**Regulatory Review of GEH Topical Report
“BWRX-300 Containment Evaluation Method”
NEDC-33922P, Revision 2**

NRC Staff Presentation

**BWRX-300 Small Modular Reactor
ACRS Full Committee Meeting**

April 6, 2022

BWRX-300 GOTHIC Containment Response Methodology

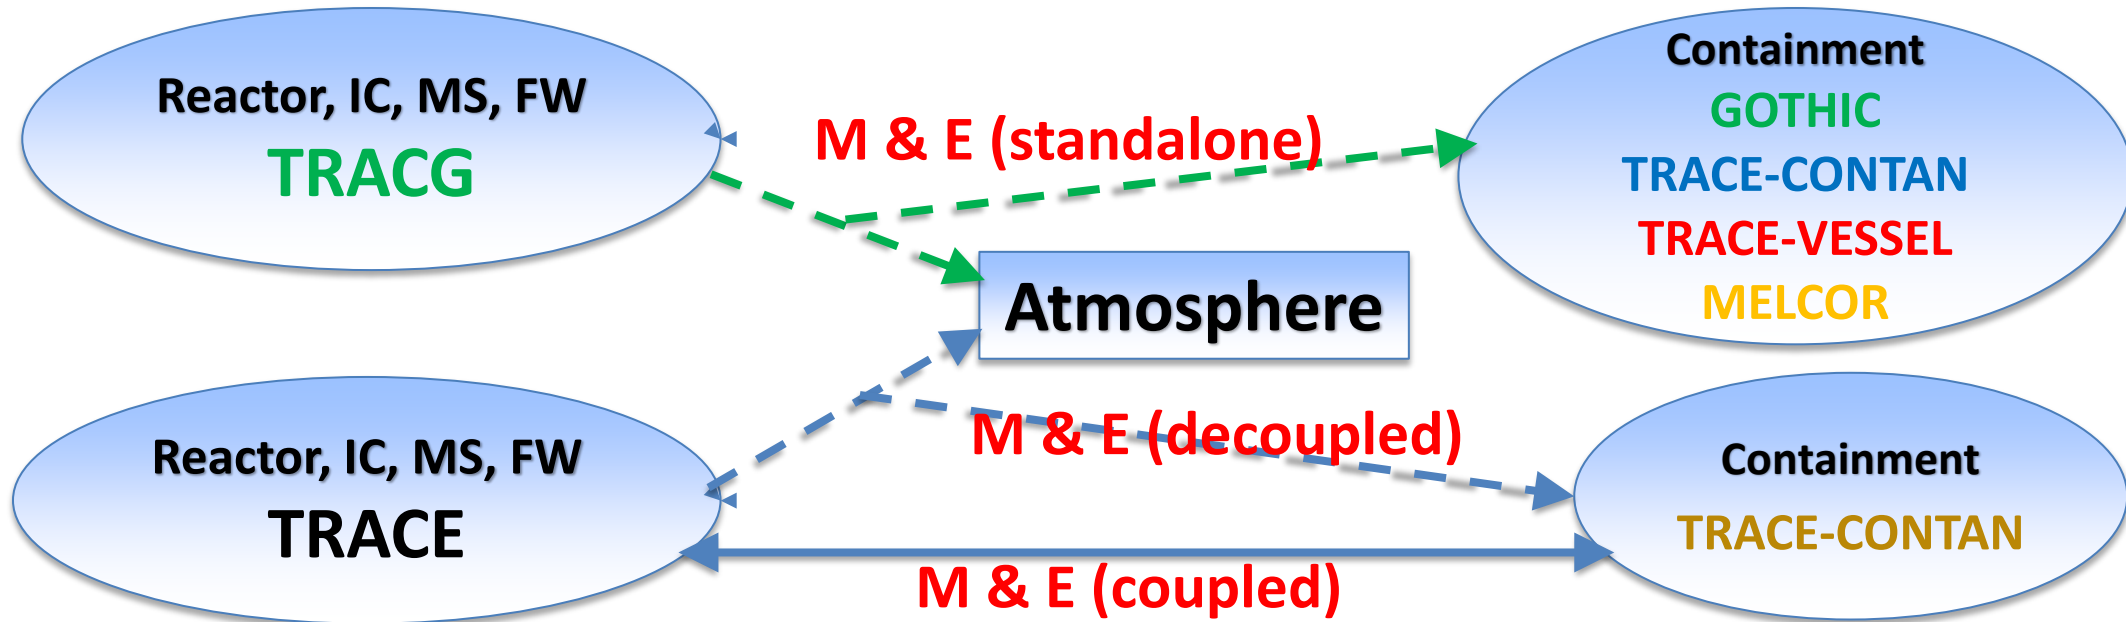
- Based on Reg Guide 1.203, "Transient and Accident Analysis Methods"
- Decoupled M&E release from the TRACG RPV model with no backpressure as a containment BC for the stand-alone GOTHIC containment model
- 4-component GOTHIC model
 - Containment (nodalized)
 - Dome (nodalized)
 - PCCS (nodalized)
 - Reactor Cavity Pool (lumped)
- Conservative Diffusion Layer Model (DLM) used for condensation
- Thermal stratification inside the containment
